## G1 2.6 red NFC

**Product Code:** R26N02313

**FCC ID:** 2ACQM-E00012

**Model ID:** R26

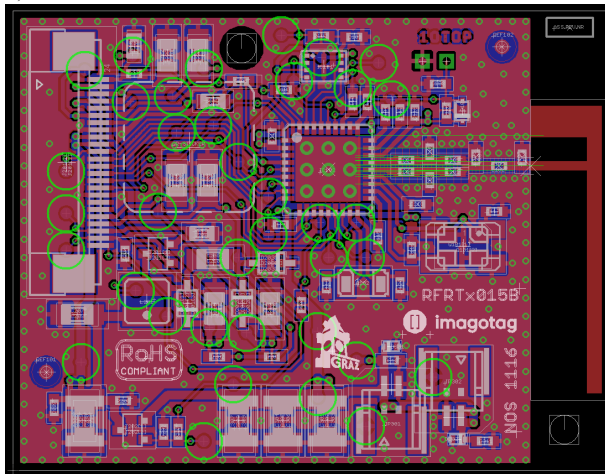
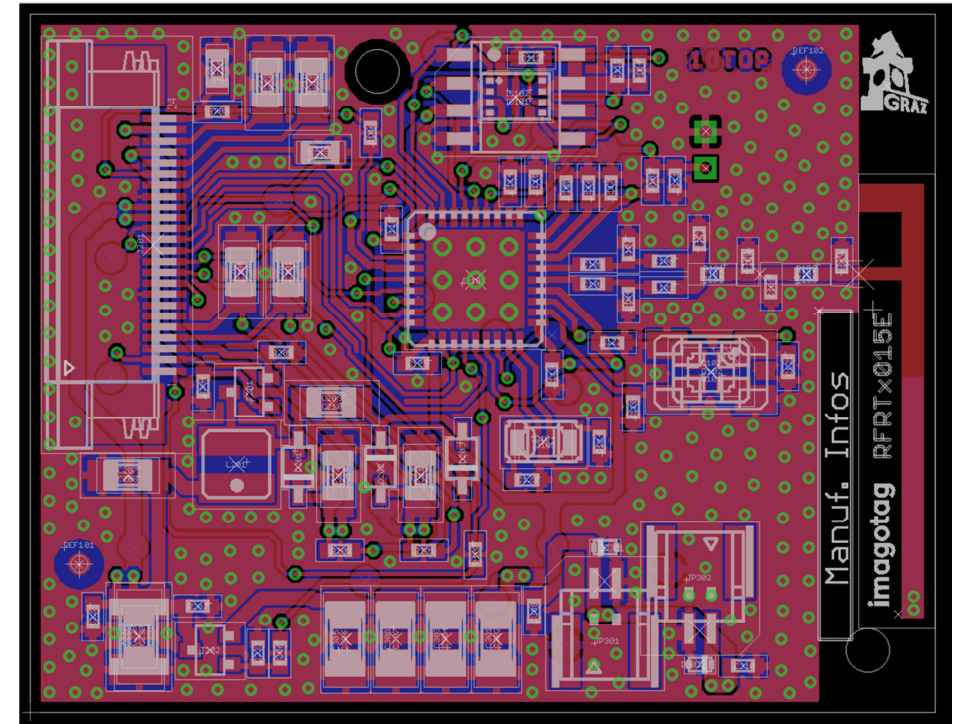
PCB cost-down resulting in a change from 4 layer to 2 layer PCB. Due to that change the antenna path and the antenna were changed. Outline remained the same besides one additional notch.

**General changes:** Some parts moved to improve fitting into modified casing. Removing of unnecessary parts. Modified Antenna.
